# SERVICE INFORMATION SI04.01

**Machines/Models:** X32

**PURPOSE:** Reduce energy on scissor arms caused by interruption of decent by PPE.

**PROCEDURE REQUIRED:** Install orifice in valve block lift/lower circuit.

**Figure 1**

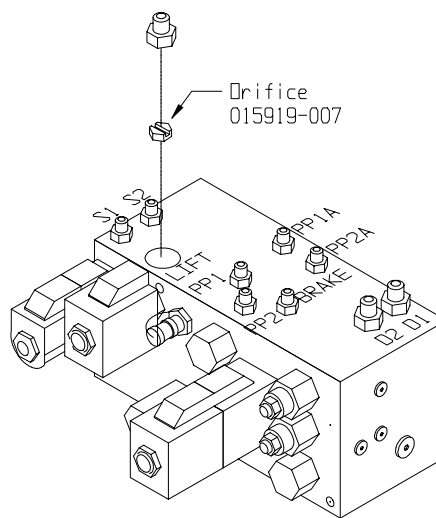
**Procedure 1** (Serial numbers 1000-15019)

1. Remove lift hose and fittings pictured in **Figure1** from valve block.
2. Install fitting #031046-001 into lift port. Install orifice #015919-007 into fitting as shown in **Figure1** with slotted side facing up.
3. Reinstall original fittings and hoses. Test for leaks and proper lift operation.
